## Report to Development Permit Panel

**To:** Development Permit Panel  
**From:** Joe Erceg  
Manager, Development Applications  
**Date:** July 28, 2003  
**File:** DP 03-233795  
**Re:** **Application by S-8065 Holdings Ltd. for a Development Permit at 8360, 8380  
and 8420 No. 2 Road**

**SITE PLAN**  
SCALE: 1" = 10'-0"

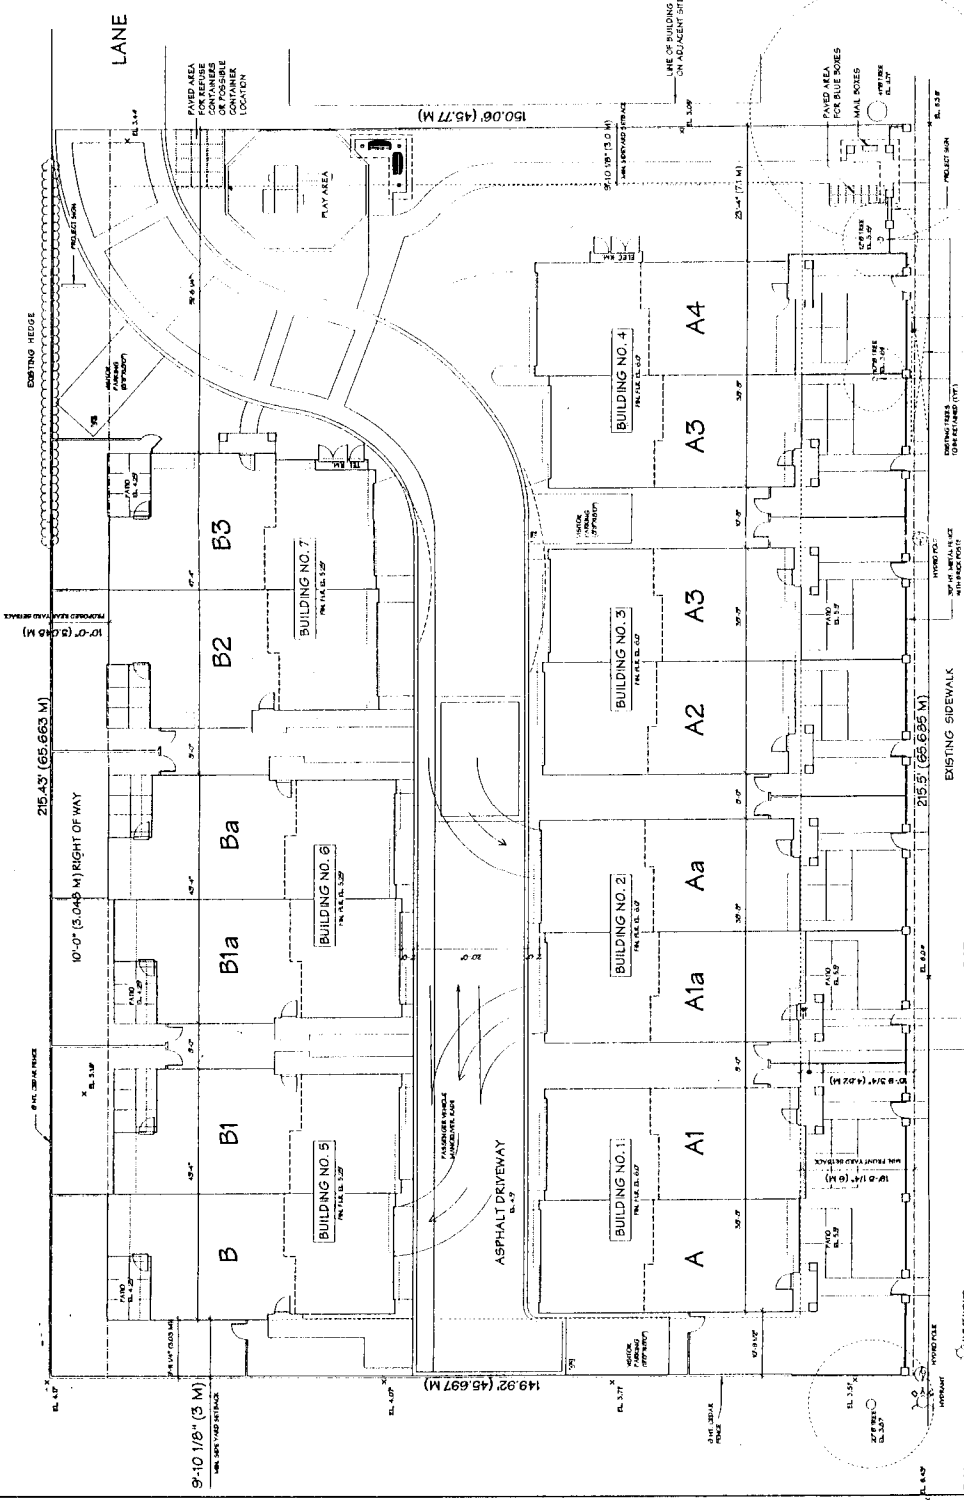
2. Show the zoning setback requirements as 'minimum' on the site plan. ***All zoning setback requirements are shown as 'minimum' on the site plan.***
3. Requested variances include the following: reduction of the front yard setback along No. 2 Road from 6 m to 4.816 m for box window and entry porch projections. ***The requested variance for box windows is on only two (2) townhouse units. CD/123 does permit porches and bay windows to project 1 m (3.281 ft.) into the front yard setback.***

6. Please dimension the space between duplex units on the site plan. If the distance between buildings is less than 2.438 m (8 ft.) then no openings are permitted along these walls. ***The distance between all the duplex units is dimensioned and is not less than 2.438 m (8 ft.).***

9. Demonstrate that there is adequate vehicle manoeuvring room for garage access and egress by providing the wheel paths for a passenger vehicle on the site plan. ***There is adequate manoeuvring room for garage access and egress as shown by wheel paths on the site plan.***

Townhouse Development - FIRE FIGHTING DIAGRAM  
8380 No. 2 Road, Richmond, B.C.

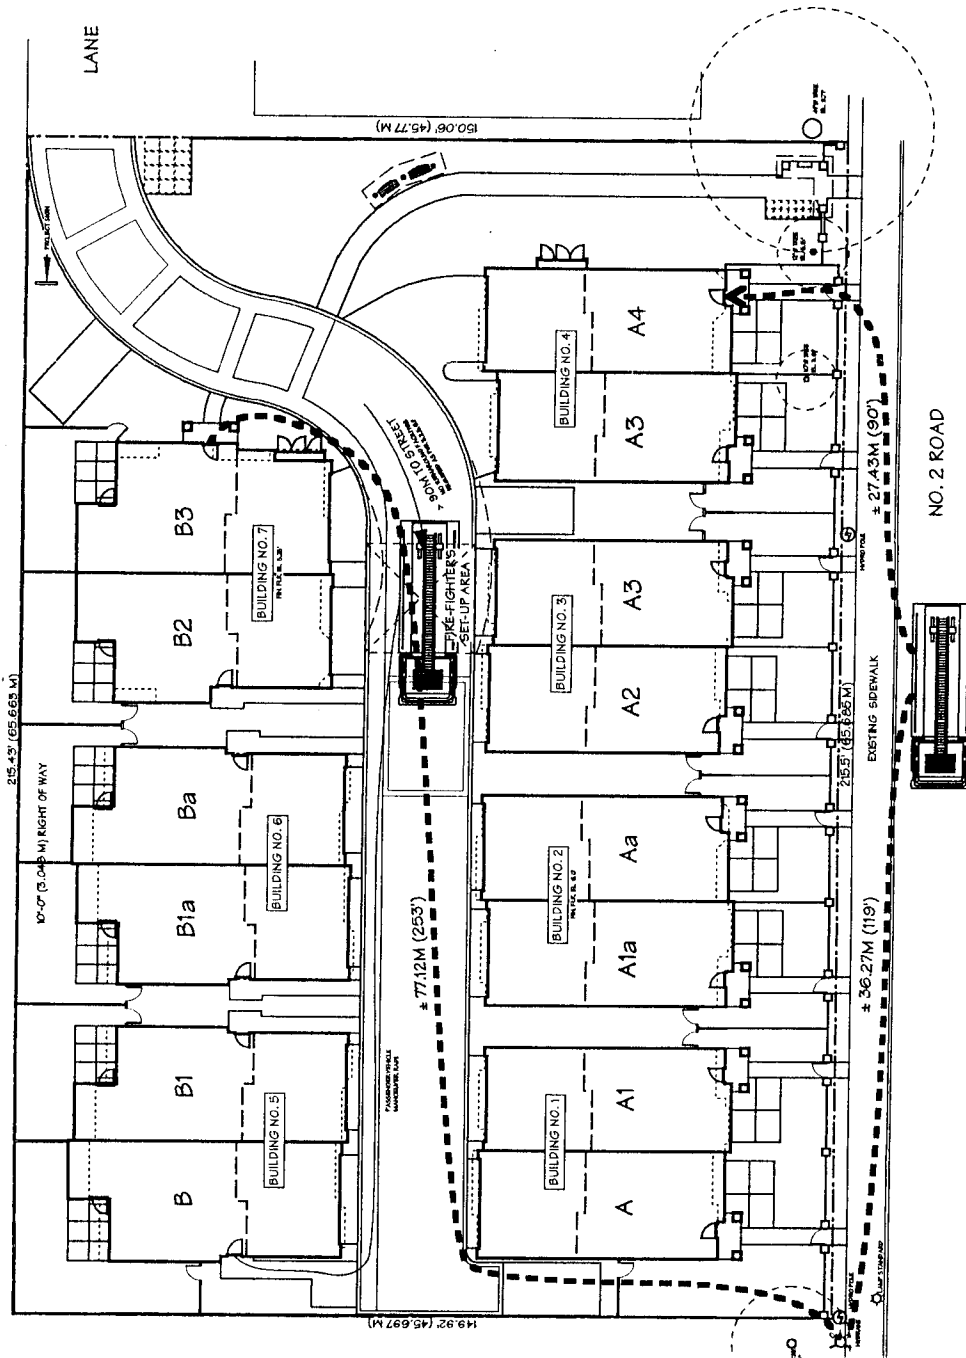
8. Input from the Richmond Fire Department is required regarding emergency fire fighting access. Please indicate the proposed strategy for emergency fire fighting access and in particular to the proposed Unit Type 'B' townhouses at the rear or east portion of the site. Illustrate on the site plan, any proposed emergency fire vehicle set-up areas complete with dimensions according to the requirements and standards of the City of Richmond's Fire Department. Indicate the sweep path (i.e. vehicle overhangs and wheel paths) for the appropriate City of Richmond's emergency fire vehicle(s) to access the site and indicate the location of existing or proposed fire hydrants to ensure that there is a hydrant within 90 m of the entrance into each unit. Ensure that there is coordination with the Richmond Fire Department. ***Fire fighting access will be through the lane and is illustrated on attached diagram.***

Drawing Title:  
 LANDSCAPE PLAN

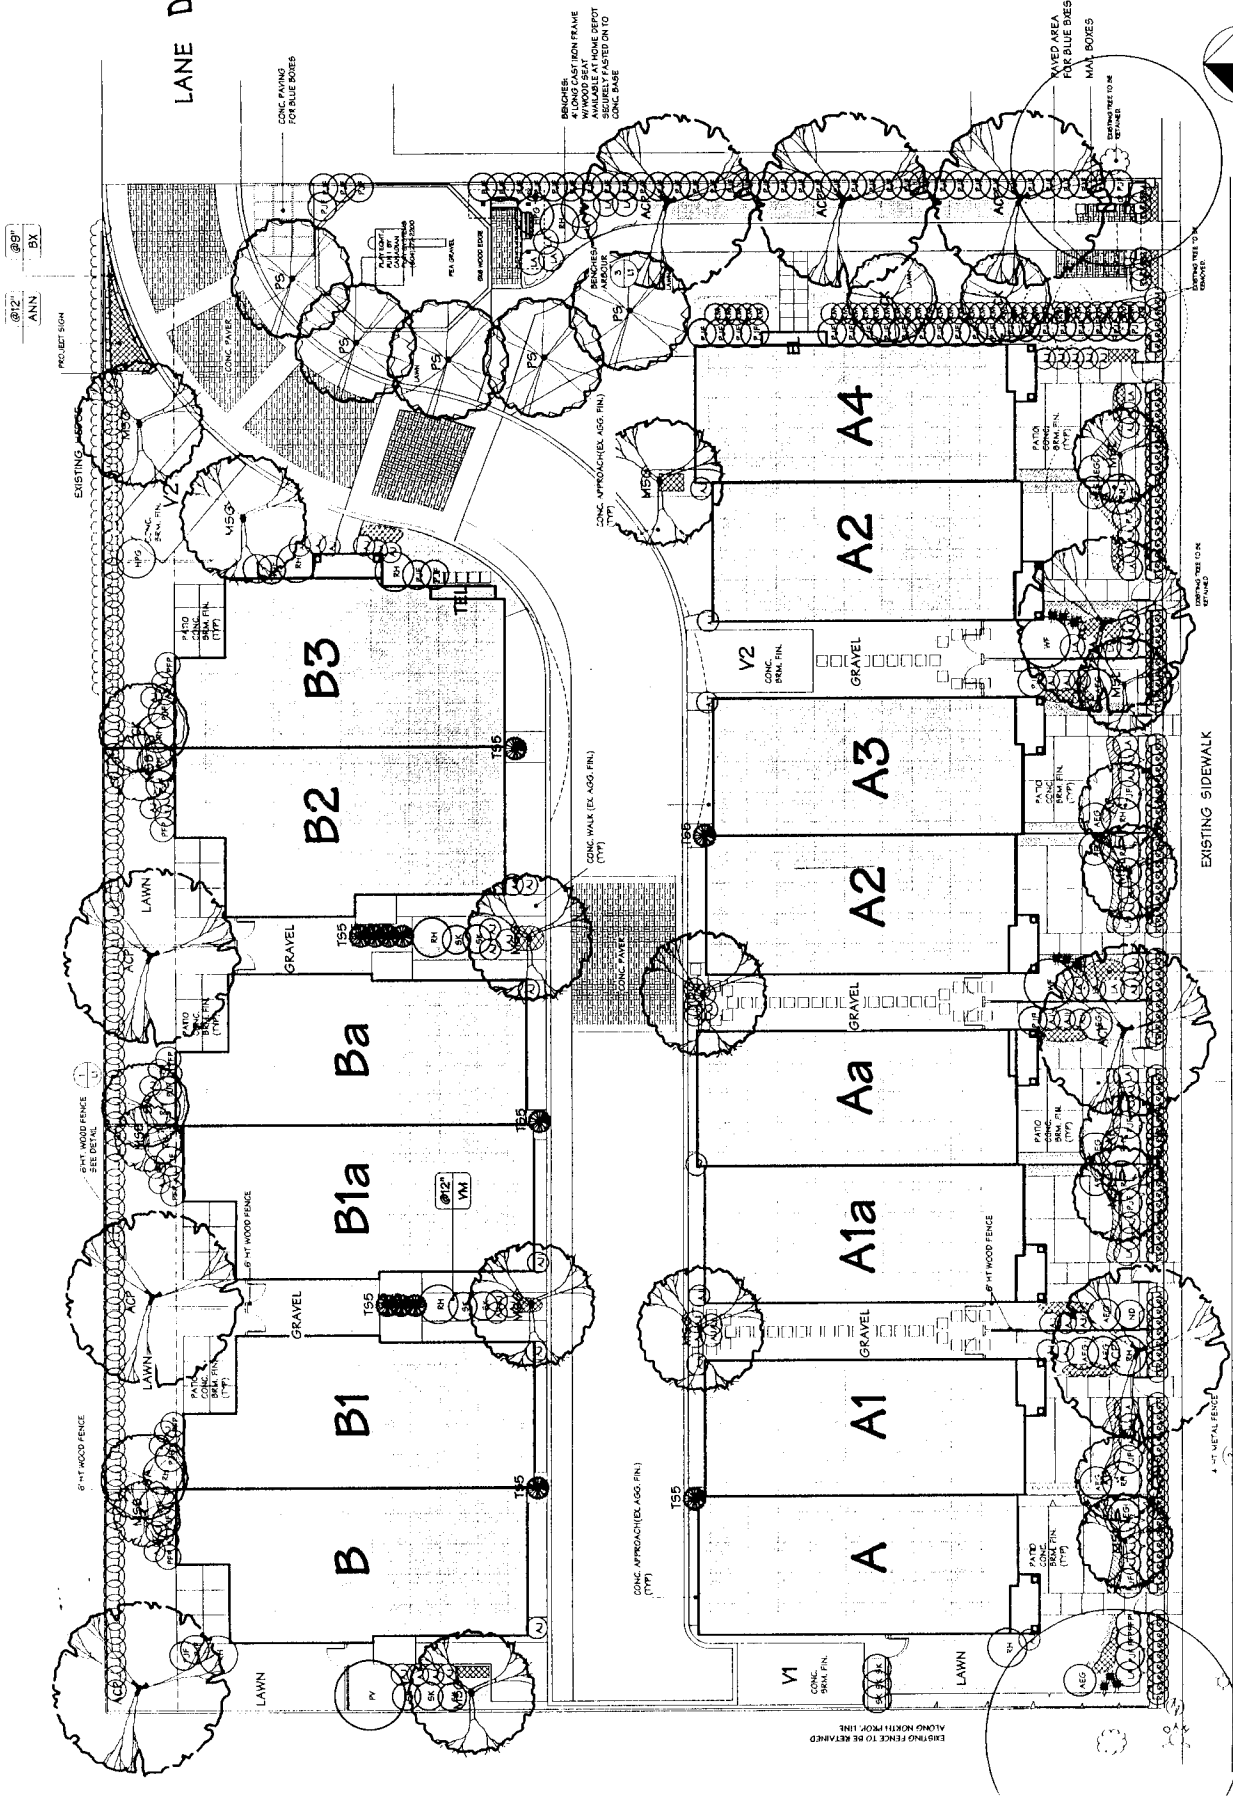
1. Tree retention and compensation was an issue during the rezoning process. ***Tree retention is shown on the landscape plan.***

11. The applicant is encouraged to provide small street trees on the City boulevard along No. 2 Road between the back of the existing sidewalk and the property line. Care should be taken to provide appropriate clearance for the existing bus stop, hydro power poles and street light locations. ***Adequate street trees are provided and shown on the landscape plan.***

DATE: APRIL 2003  
DRAWING TITLE: ELEVATIONS

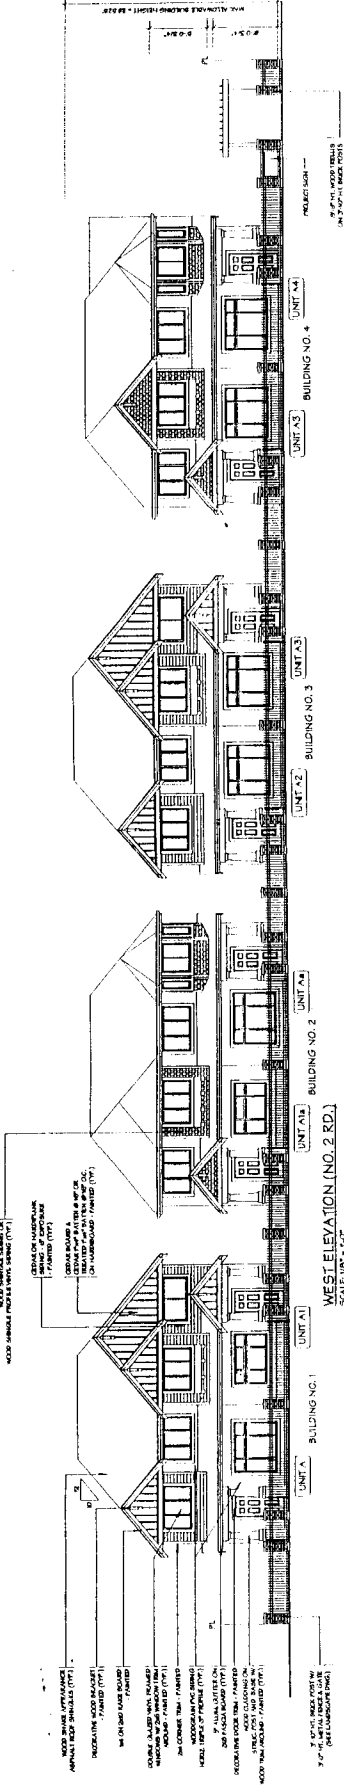
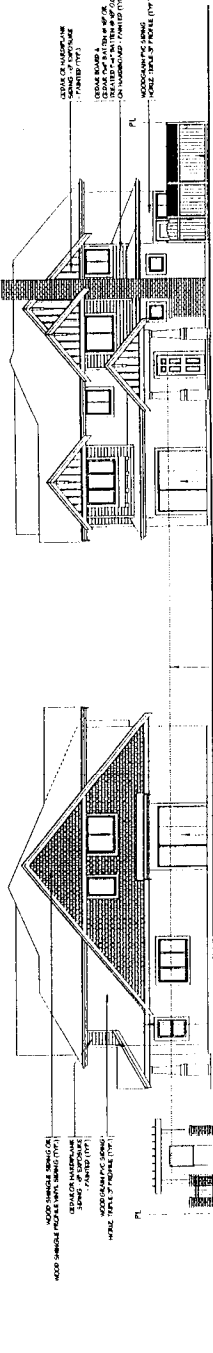
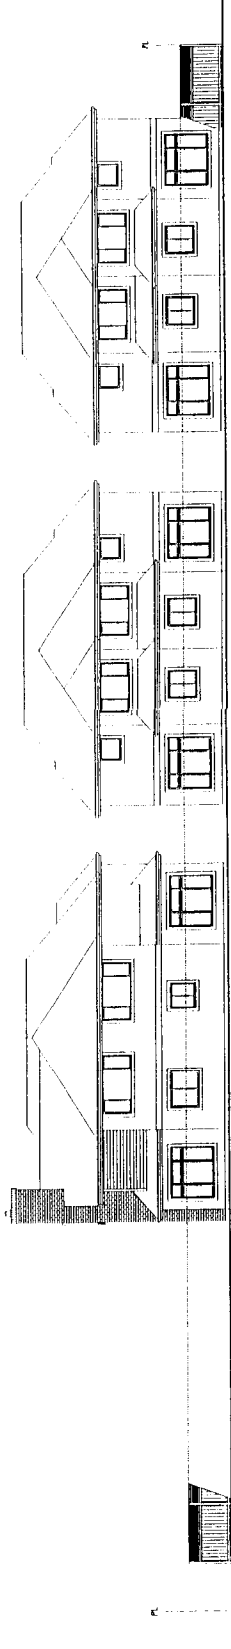
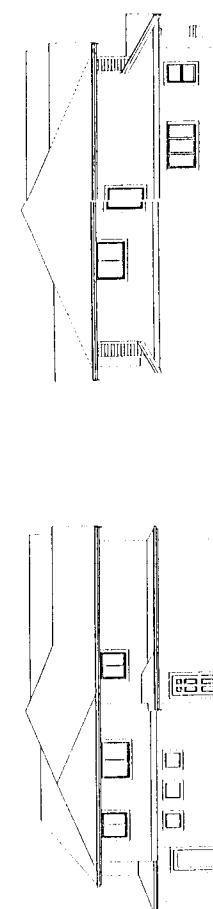
4. Provide a series of continuous building elevations around the entire perimeter of the site as well as detailed architectural elevations for each façade of every building with all proposed cladding materials clearly indicated. ***A series of continuous building elevations is provided.***

1000 W. 10TH AVENUE, SUITE 200, DENVER, CO 80202  
DRAWING TITLE: SITE CROSS SECTIONS

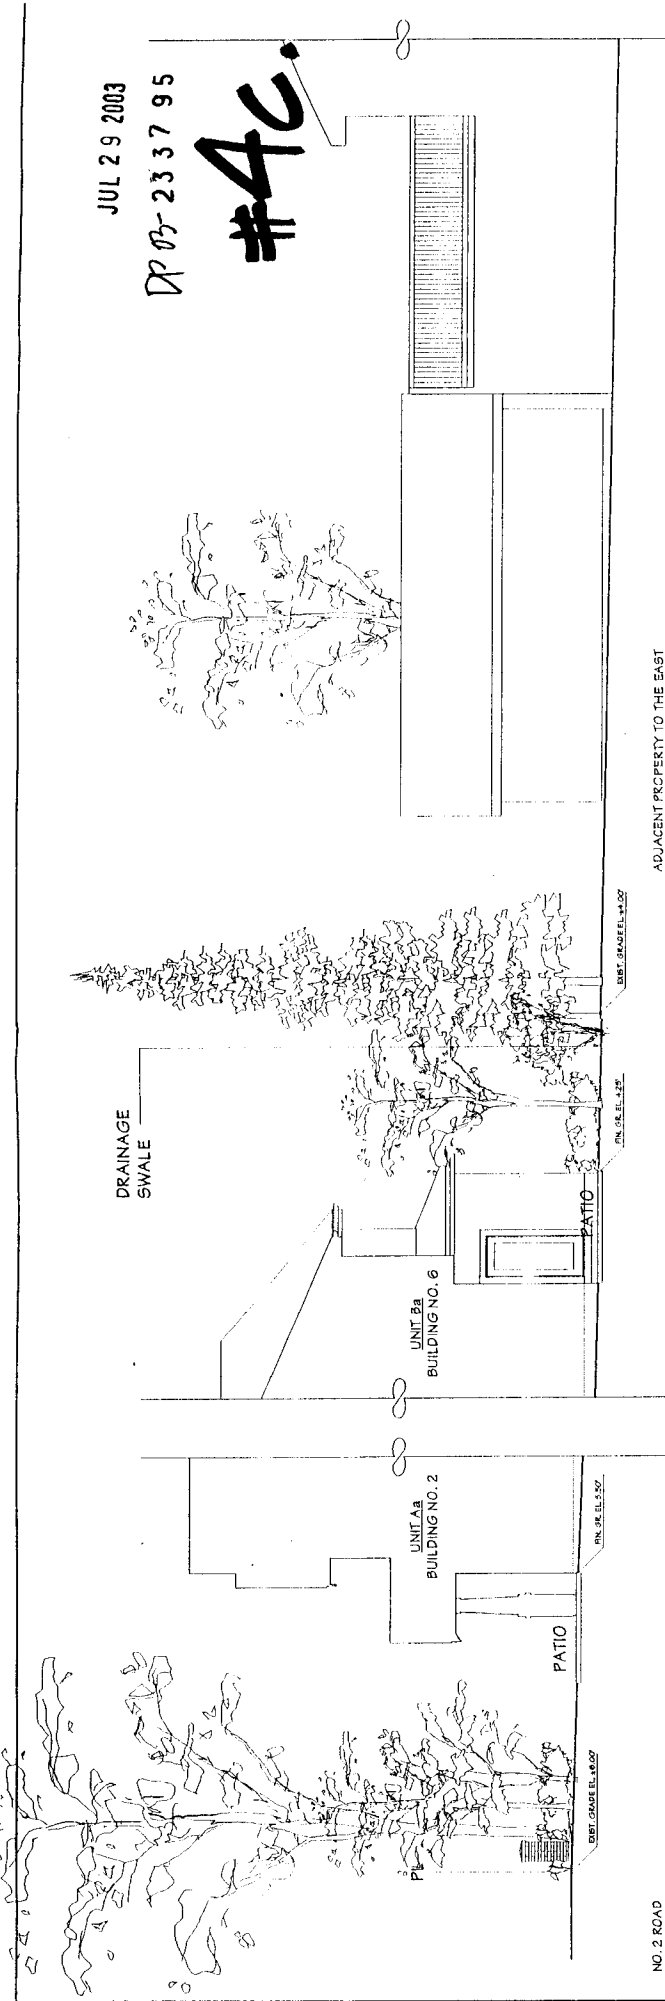
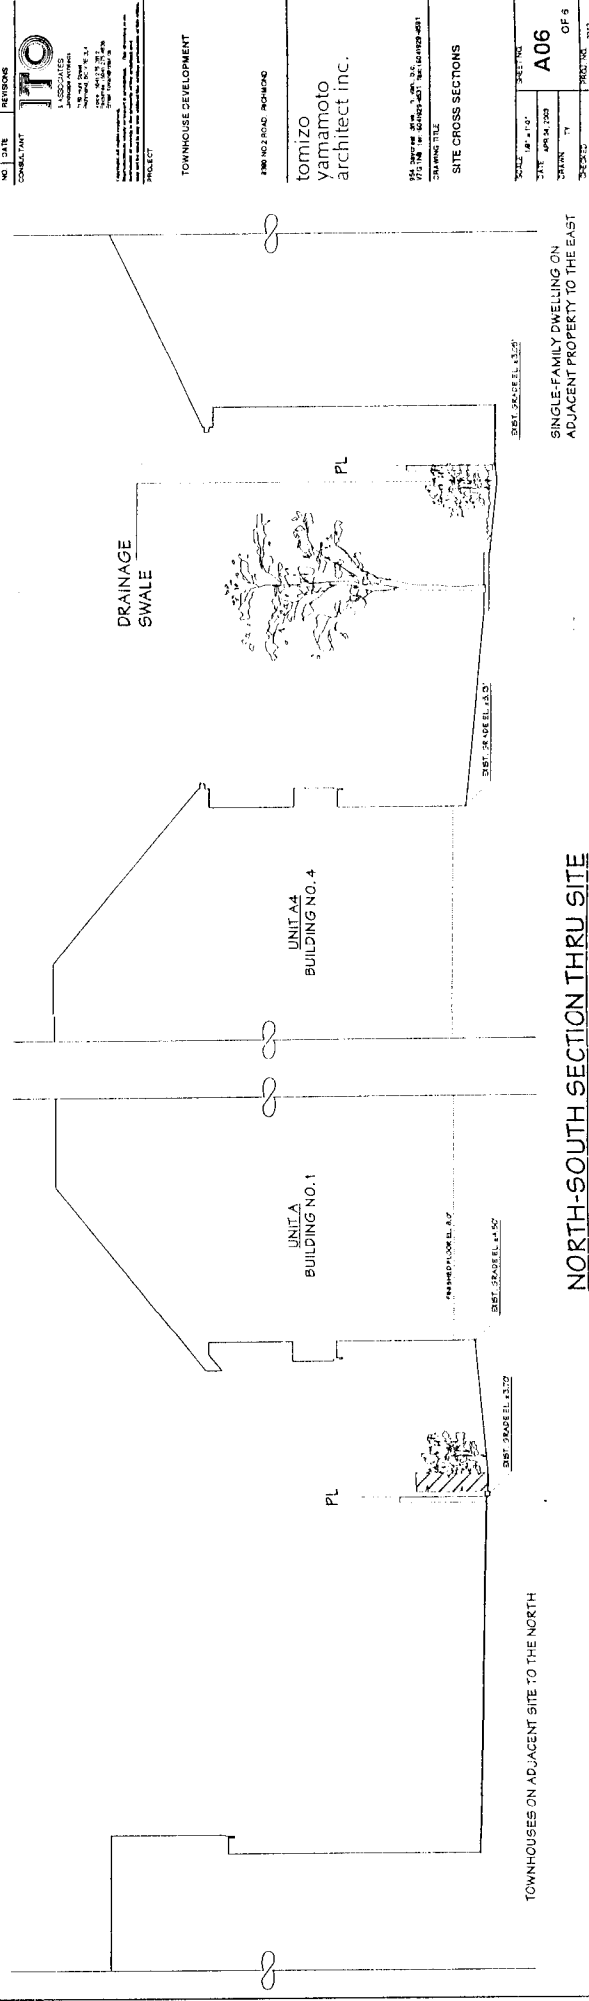
5. Provide a series of cross sections through the site to illustrate the relationship between the proposed buildings and grades in relation to existing grades and neighbouring buildings around the perimeter of the subject site. Provide appropriate landscape screening around the perimeter of the site and pay special attention to landscape buffering for the adjacent, existing residential development to the north, east and south of the subject site. ***Cross sections through the site to illustrate the relationship between the proposed buildings and grades to the north, east and south of the subject site are shown.***
